Groundwater Application Review Summary Form

Application # G- 18847

PUBLIC INTEREST REVIEW FOR GROUNDWATER APPLICATIONS

TO: Water Rights Section Date 12/5/2019
 FROM: Groundwater Section Joe Kemper
 Reviewer's Name
 SUBJECT: Application G- 18847 Supersedes review of na
 Date of Review(s)

Figure 1. Water Availability Tables

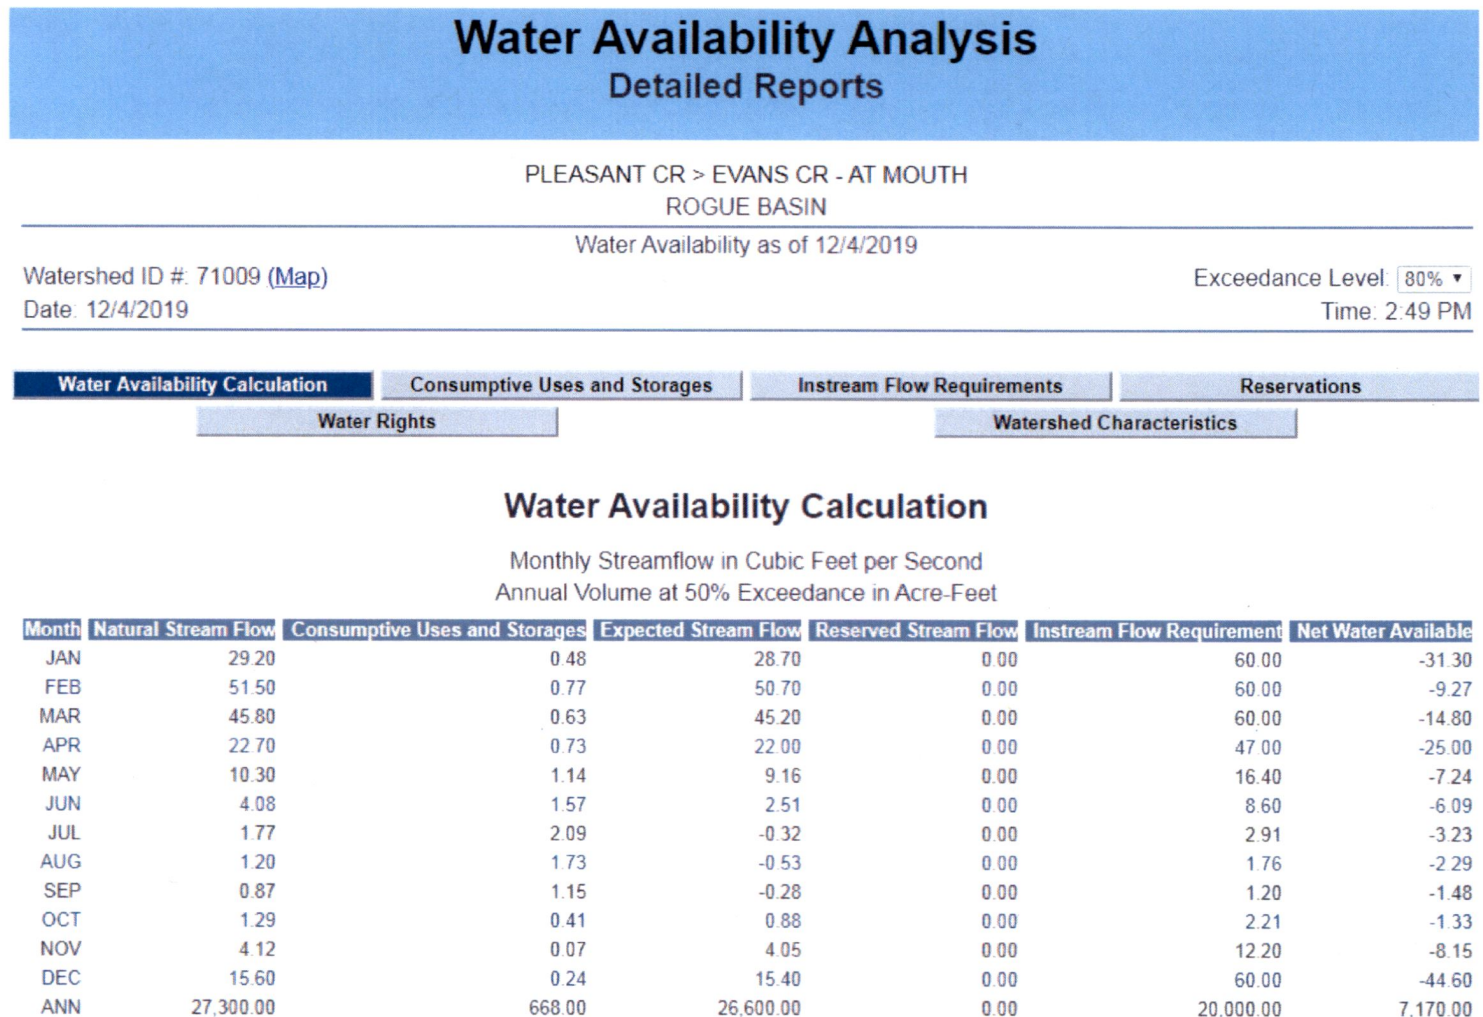
Water Availability Basin the well(s) are located within: PLEASANT CR > EVANS CR - AT MOUTH

Figure 3. Stream Depletion Model (Hunt, 1999)

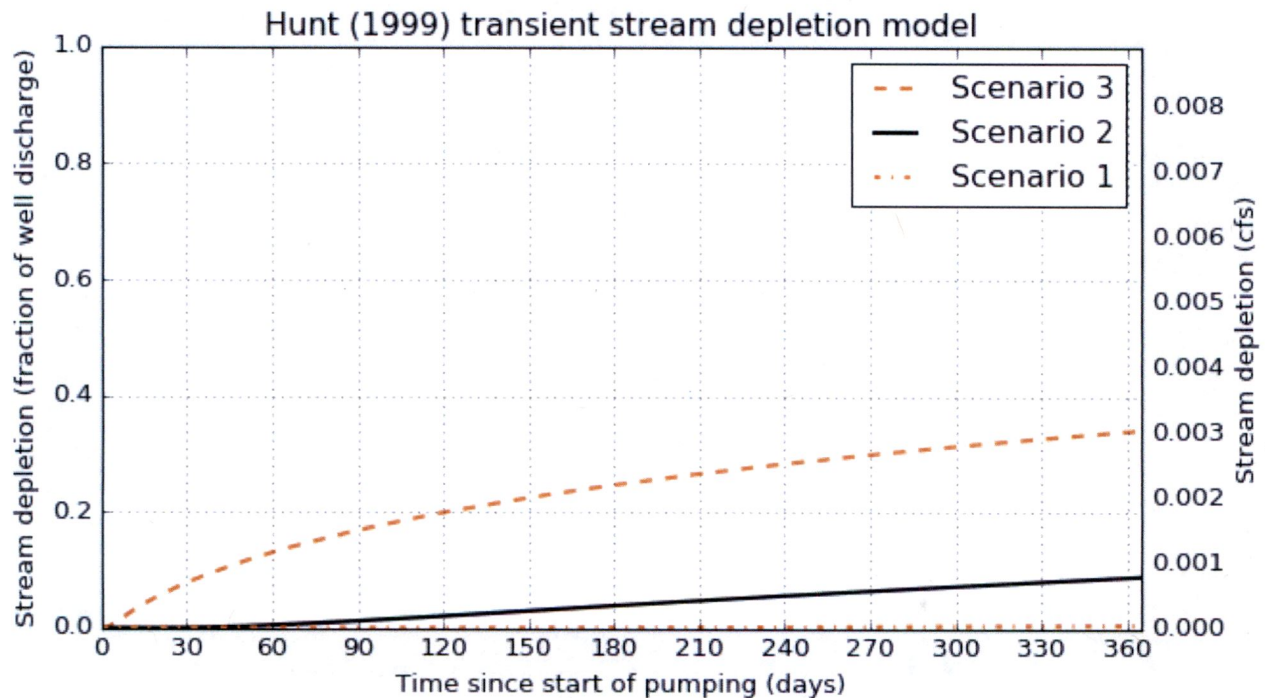
Comments: Streamflow depletion is estimated using an analytical stream depletion model (Hunt, 1999) using bulk aquifer parameters representative of the local geology. The applicant's requested rate is 4 gpm (~0.0089 cfs). While this rate is technically higher than 1% of the 80% natural flow (0.0087 cfs), the difference is assumed to be negligible for the purposes of this review. Thus, the requested rate is equivalent to the 1% of 80% natural and does not trigger an assumption of PSI as per OAR 690-009-0040(4) (c).

C6. **SW / GW Remarks and Conditions:** The applicant's well accesses an aquifer that has been determined to be hydraulically connected to Pleasant Creek. However, there is not a preponderance of evidence that the proposed use/rate has the Potential for Substantial Interference (PSI) as per OAR 690-009.
